**PLANNING COMMISSION MEETING  
MUNICIPAL CENTER COUNCIL CHAMBERS  
Tuesday, August 7, 2018**

### 6. Goodwin Farms PUD: Final Plan – Phase 1

Development Case Number	17-729
Case Name:	Goodwin Farms PUD
Location:	North side of Winchester Rd., approx. 1,000 ft. east of Crestwyn Dr.
Owner Name/Applicant:	Regency Home Builders – Paul Ryan
Representative Name:	SR Consulting – Cindy Reaves
Zoning District:	“R” Single-Family Residential
Area:	22.137 acres
Request:	Approval of Final Plan, Phase 1 (21 lots and Common Open Space)

**FINAL PLAN**  
 (See complete plan set in agenda packet)

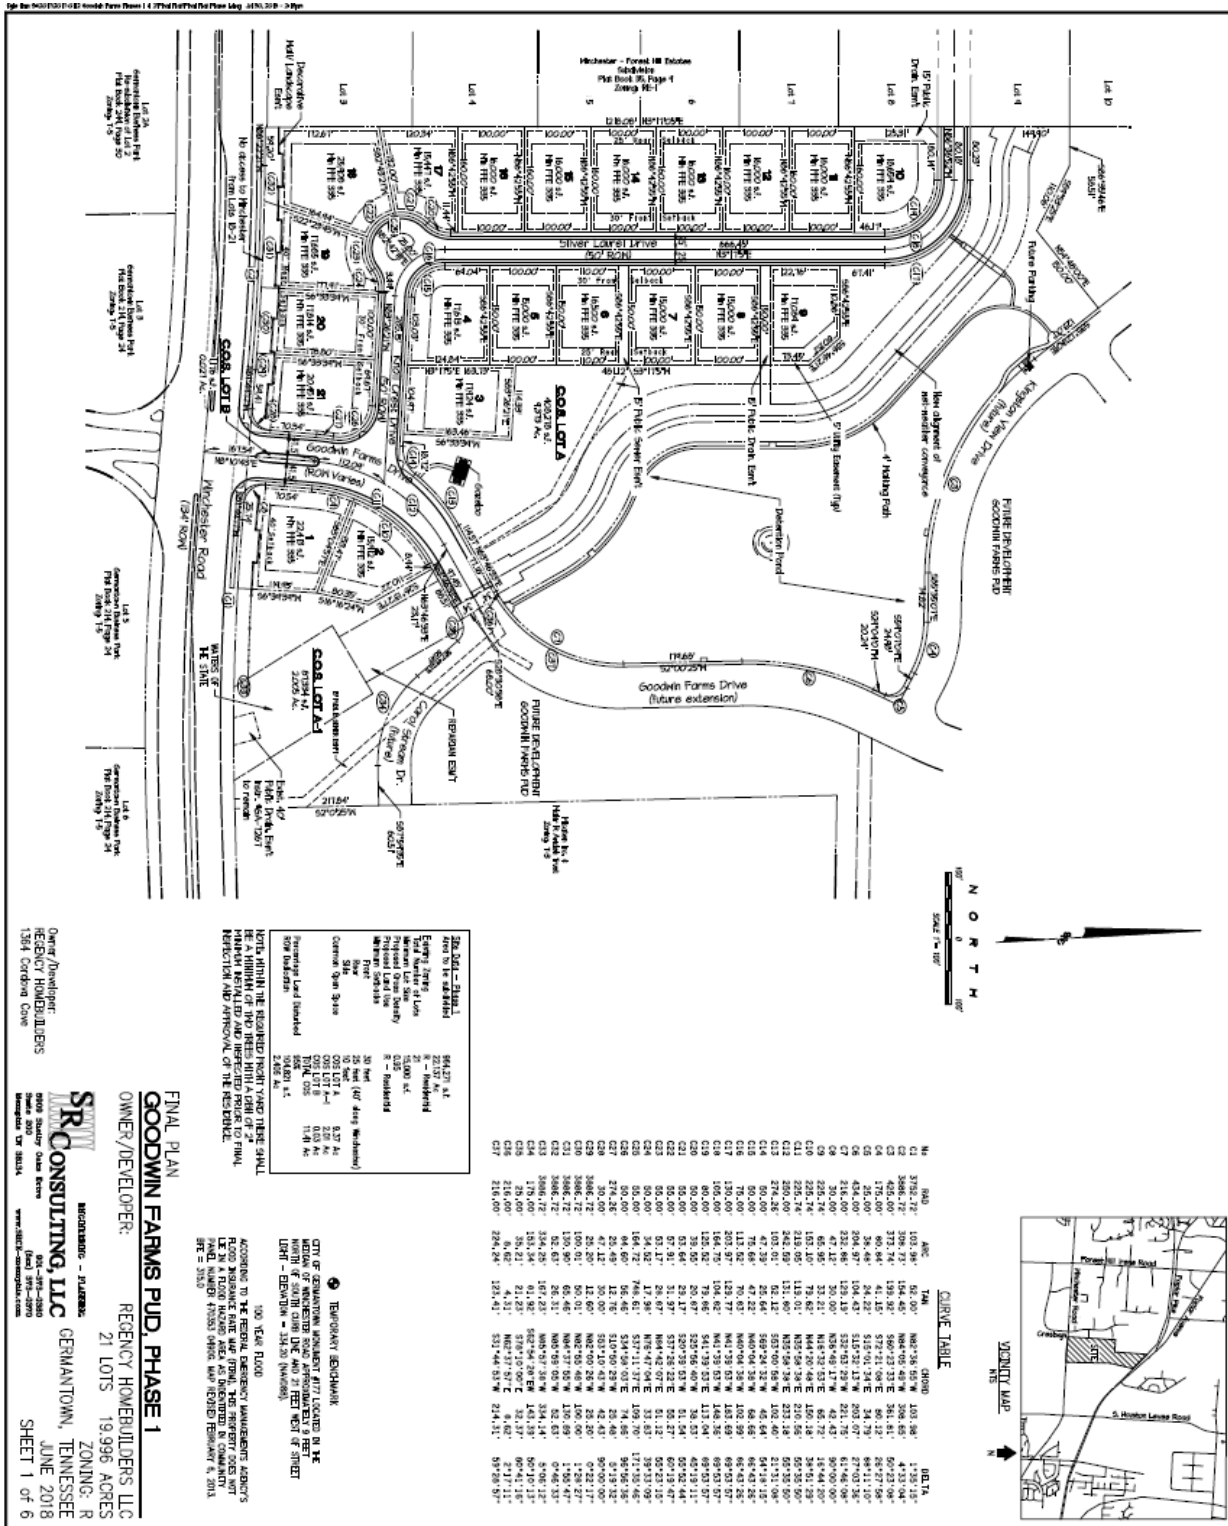
1. A sheet identifying fire department access for the aerial apparatus using an auto turn program shall be provided.
  2. Sheets C01.5 and C05.0 illustrates a hammer head in lieu of a cul-de-sac. Comments on the "Final Plan" sheet 3 of 3, Section VI, Note 6 indicate a 96' diameter cul-de-sac.

3. Sheet C02.4, Utility Crossing Notes #4, indicates the 12" water main will be reduced to an 8" water main. Water flow calculations reflecting the change shall be provided.
